PHOTOGRAPHS

PHOTOGRAPH #2

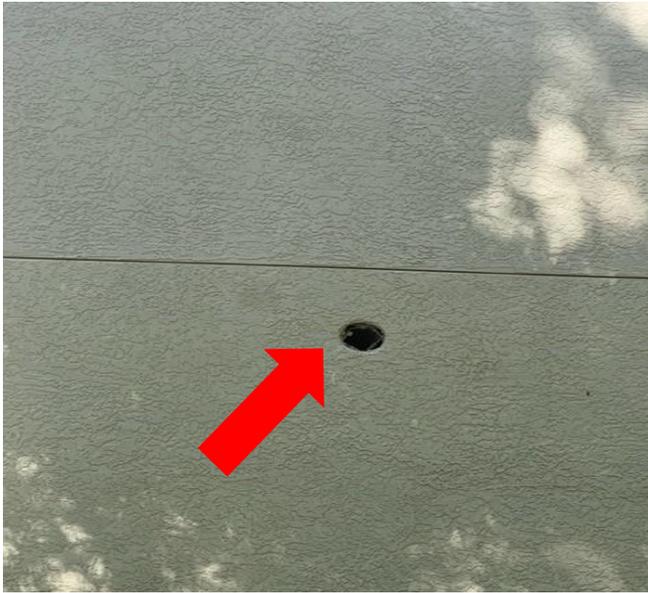
Separation from ground to new stucco does not meet drawings requirements.

PHOTOGRAPH #5

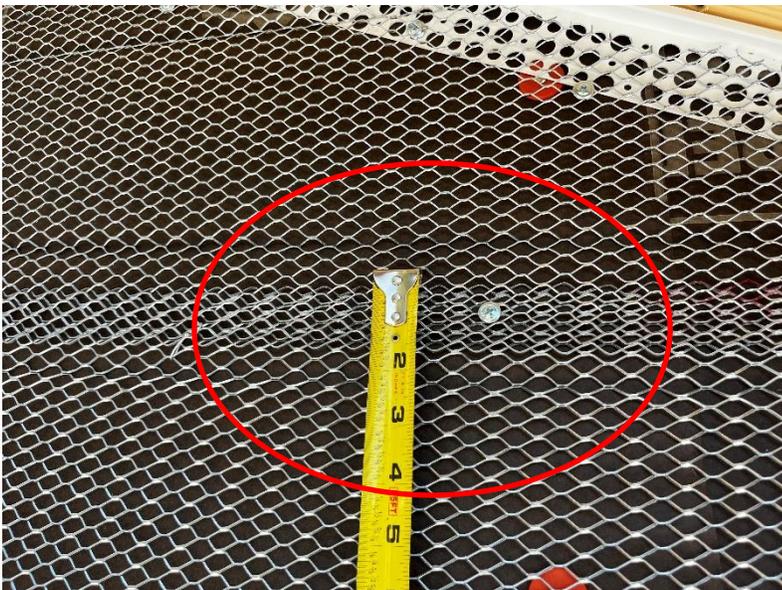
Stucco sub-contractor installing new self-furring galvanized metal lath and vinyl stucco accessories.

PHOTOGRAPH #7

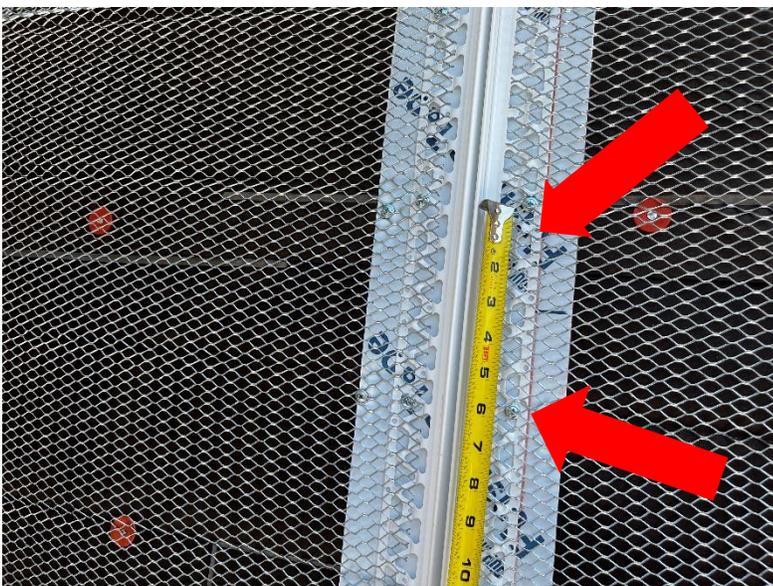
Side laps of metal plaster bases tied between supports with wire at no more than 9" O.C. .

PHOTOGRAPH #8

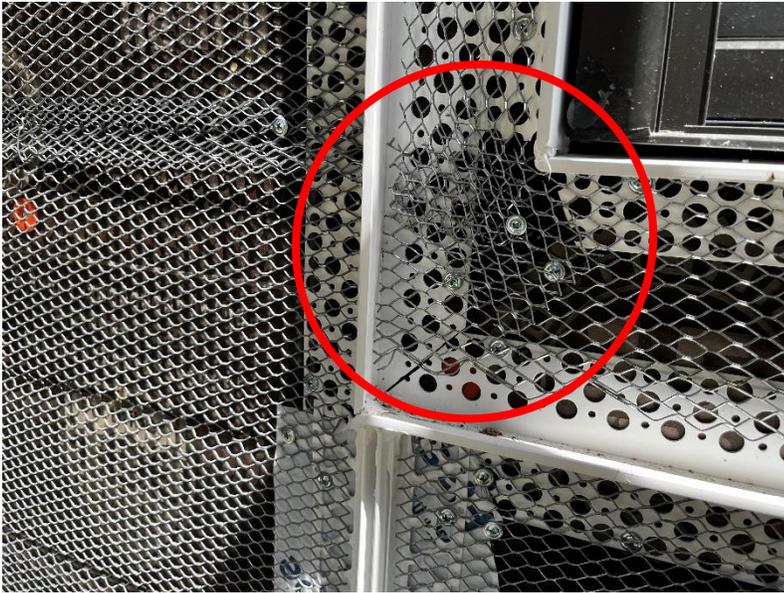
Control joint flanges secured at no more than 7" intervals as per ASTM 1063. .

PHOTOGRAPH #15

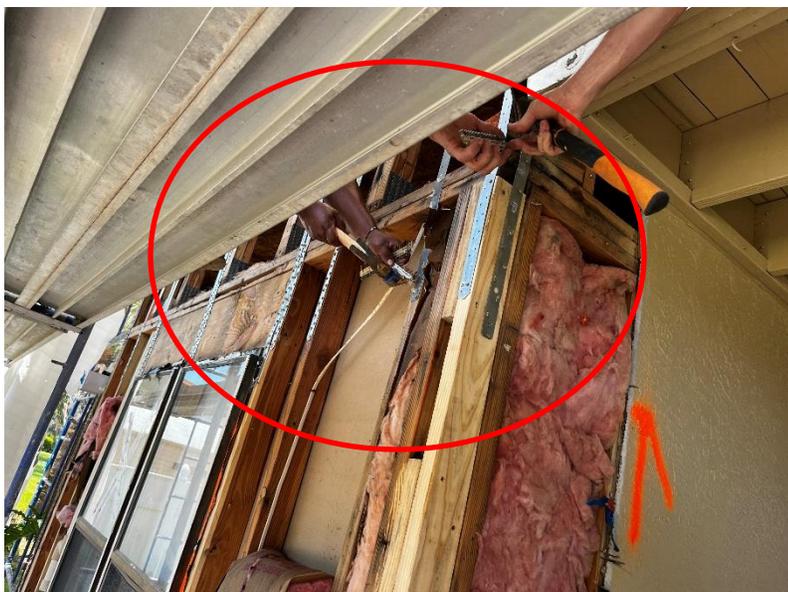
Simpson Strong -Tie connector
MSTC48B3 attaching breezeway studs
pack to cedar beam installed as per
drawings.
